IMC

2015 GROUP A PUBLIC COMMENT AGENDA

SEPTEMBER 30 – OCTOBER 5, 2015
LONG BEACH CONVENTION CENTER
LONG BEACH, CA

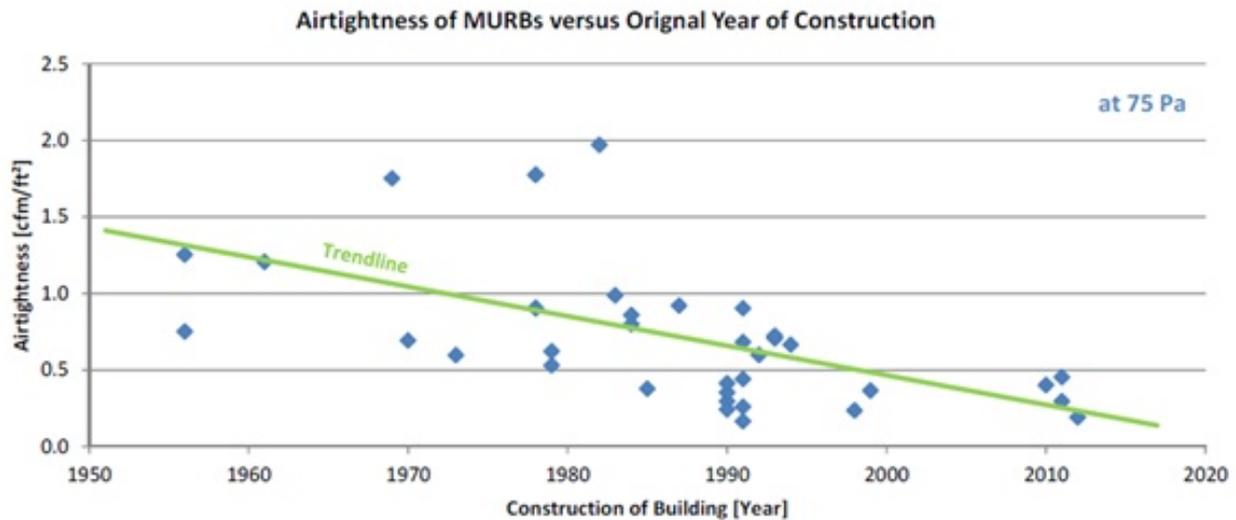
In other words, by the IRC and IMC's own standards, typical dwelling units, regardless of whether or not they have a blower door test, should be provided with mechanical ventilation. This proposal limits the requirements for mechanical ventilation to the dwelling units that will have the highest impact on occupant health - those units whose occupants are expected to be nontransient, since these account for the lion's share of pollutant exposure over time. The definition of nontransient is adapted from the IBC definition of transient.

Examples of "mechanical walls" showing the abundance of utilities in this wall, demonstrating the need to provide more than 3.5"

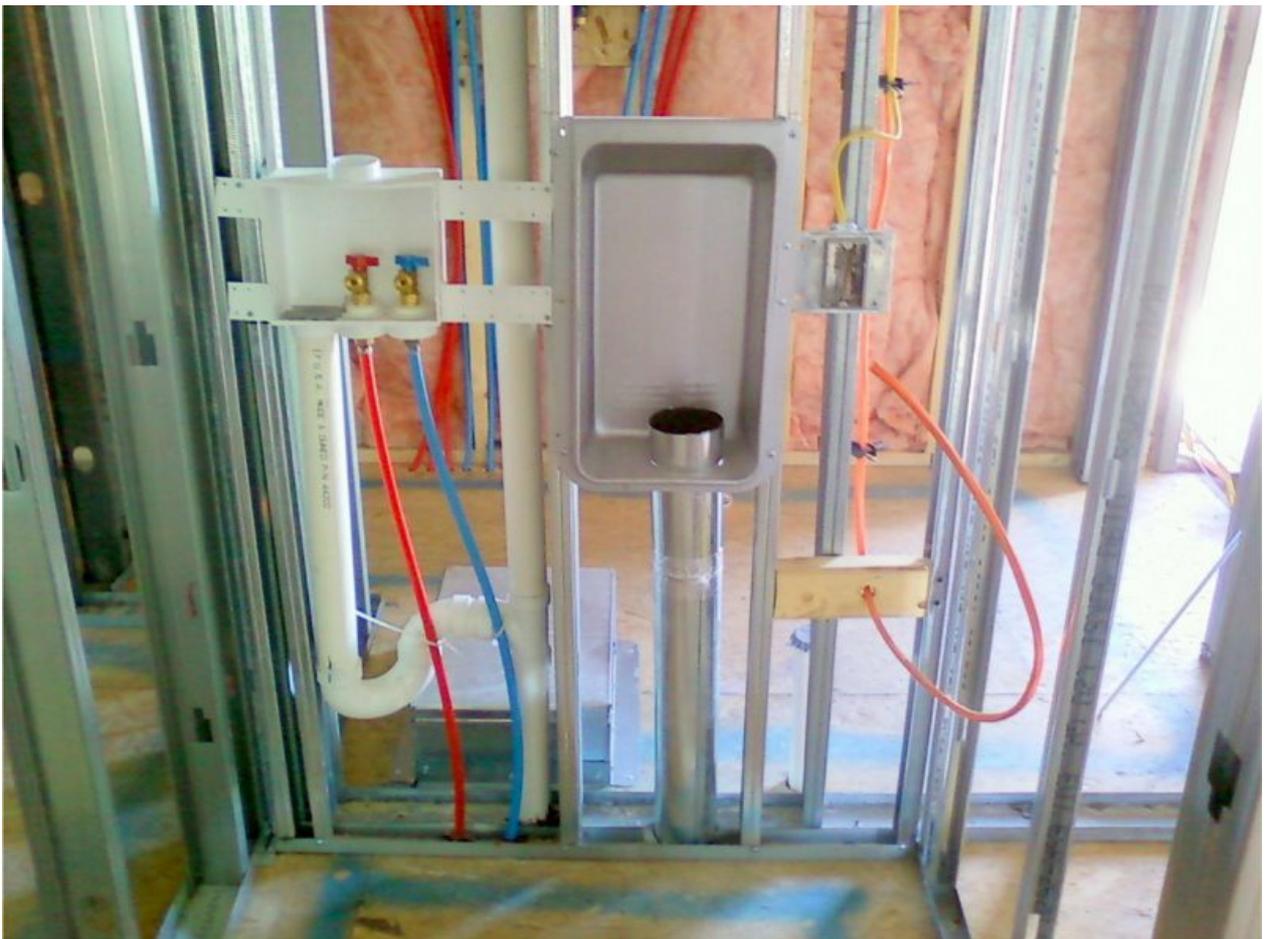
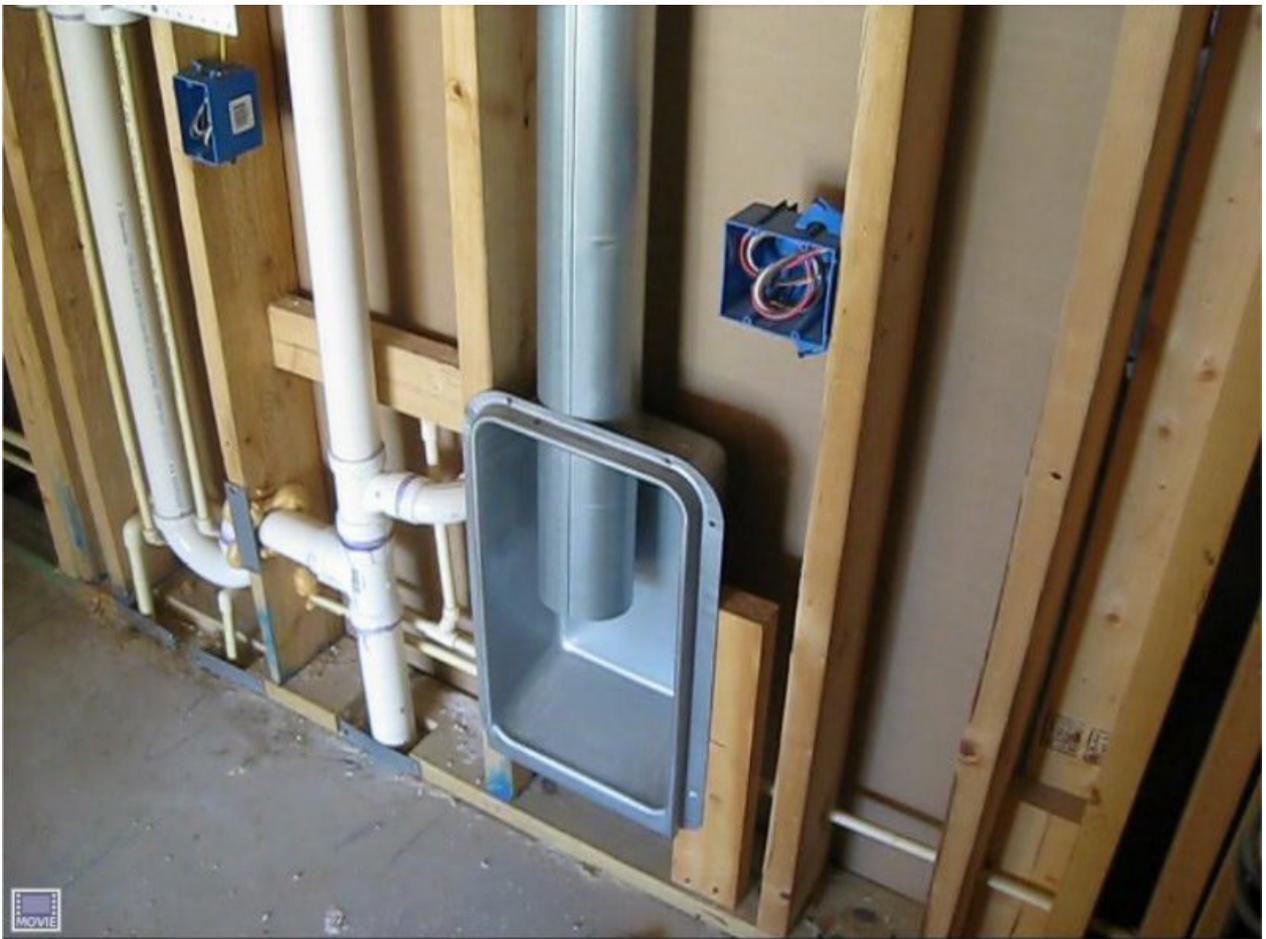
A 1 inch furring strip (1x2) can be added to a 2 x 4 stud providing the 4.25 inches of space. In most cases, this "mechanical" wall is busy with other trades (plumbing drainage and vent stacks, gas piping, electric service, laundry services and water piping). A 4.25 inch space will benefit all of the trades working within that space. The minimum space required to keep the dryer exhaust duct round is 4.125 inches. This dimension could also be referenced here, however, most contractors will simply use a furring strip on a 2 x 4 to provide the minimum spacing for the duct.

Disapproved

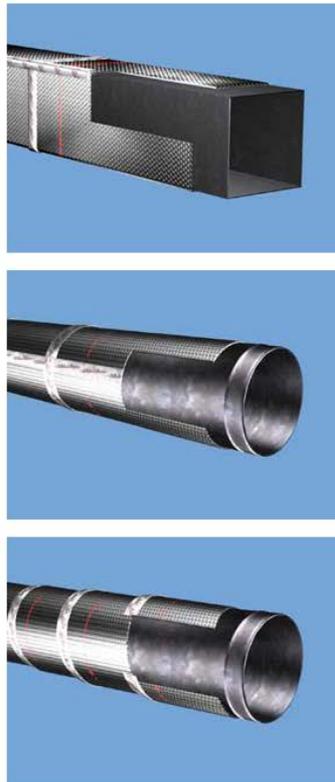
There is nothing in the code that prohibits the use of reflective duct insulation and, in fact, this product is commonly and widely used throughout the country. To the Committee's point cited in the Report on the Committee Action Hearing, this is exactly why the proposed language is absolutely needed. This language will ensure that proper installation of this product occurs.

Industry Standard Labeling Practice: Products that require spacers (to provide stated R-value) are labeled with the product installed directly to the duct (no spacer) and the product installed utilizing a spacer (typically 0.75 inches).

Drawing Illustration courtesy of Reliance Worldwide - SharkBite® Installation Instructions

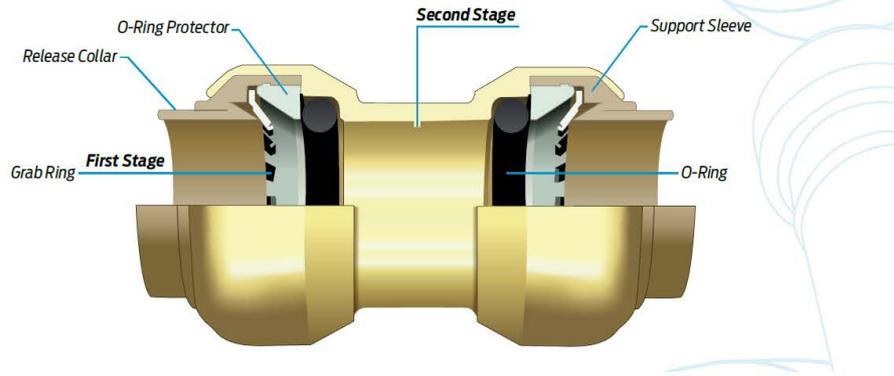
Public Comment: Supporting information
M137-15 : Adding ASSE 1061 Push-fit fittings to TABLE 1202.5
HYDRONIC PIPE FITTINGS

The SharkBite® connection system uses an advanced push-fit design that works in two stages. When the tube is inserted into the fitting it passes the first stage through a release collar and then through a stainless steel grab ring. The grab ring has teeth that open out and grip onto the tube. At the second stage the tube is pushed through an o-ring protector which aligns the tube. A specially formulated o-ring is then compressed between the wall of the fitting and the tube before the end of the tube reaches the tube stop.
